GRACELAND SUBDIVISION

APPLICATION NUMBER 5 DATE June 2, 2005

REQUEST Subdivision

DETAIL SITE PLAN

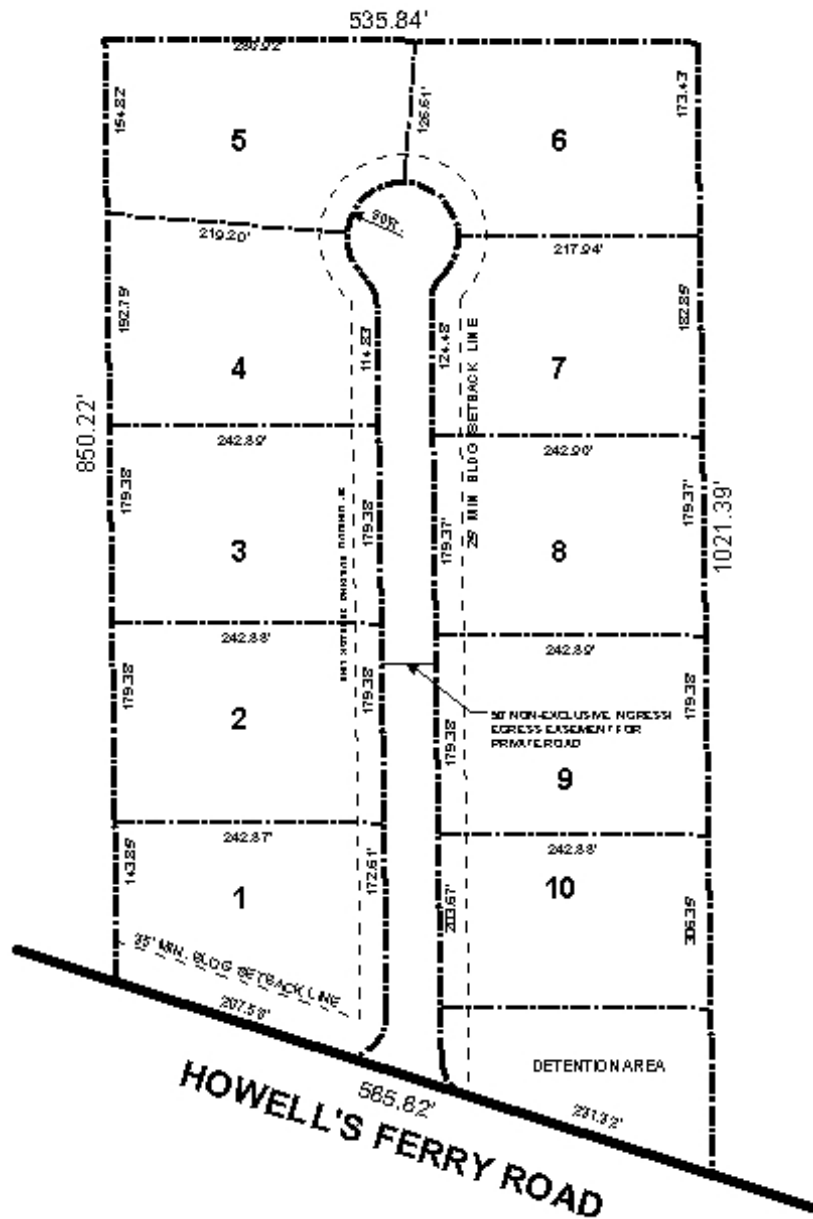
As Howells Ferry Road / Spring Hill Avenue - Ziegler Boulevard thoroughfare is a proposed major street, access management is a concern. A note should be placed on the Final Plat stating that lots 1 – 5 are denied direct access to Howells Ferry Road / Spring Hill Avenue - Ziegler Boulevard thoroughfare.

The private street is depicted as an easement on the plat. Section VIII.E.2.c. of the Subdivision Regulations require that private streets be provided as private rights-of-ways, rather than

easements, to ensure accessibility to all properties that are to have access to the private street. Therefore if the subdivision is approved, the note on the plat stating “50’ *NON-EXCLUSIVE INGRESS/EGRESS EASEMENT FOR PRIVATE ROAD*” should be revised to reflect the Subdivision Regulations’ requirements. Furthermore, the proposed private street must be built to the minimum standards listed in the Section.

It should also be noted that Section VIII.E.1.b. states “*Subdivisions in which Private Streets are allowed shall not be adjacent to large undeveloped potentially landlocked tracts of property where a street stub would be required.*” The site, in fact, abuts approximately 275 acres of land to the north that is currently landlocked. Access to the landlocked area from the north is limited due to the presence of Crooked Creek and its associated floodplains and wetlands. Thus the denial of the private street and the provision of a public street with a street stub to the north is recommended.

A note should also be placed on the plat, if approved, stating that maintenance of the detention basin common area is the responsibility of the subdivision’s homeowners association.

Based upon the proceeding, the plat is recommended for Tentative Approval, subject to the following conditions: 1) the denial of the private street request, with the street being replaced by a dedicated public street built to Mobile County standards, and with a street stub to the north; 2) the dedication of 10 feet of right-of-way along Howells Ferry Road, including that contained within the proposed detention area; 3) the provision of a minimum rear yard setback of 58 feet for lots 1-5; 4) placement of a note on the Final Plat stating that lots 1 – 5 are denied direct access to Howells Ferry Road and the Spring Hill Avenue - Ziegler Boulevard thoroughfare / new connector to Moffett Road; 5) placement of a note on the Final Plat stating that any lots which are developed commercially and adjoin residentially developed property must provide a buffer, in compliance with Section V.A.7. of the Subdivision Regulations; and 6) placement of a note on the Final Plat stating that maintenance of the detention basin common area is the responsibility of the subdivision’s homeowners association.
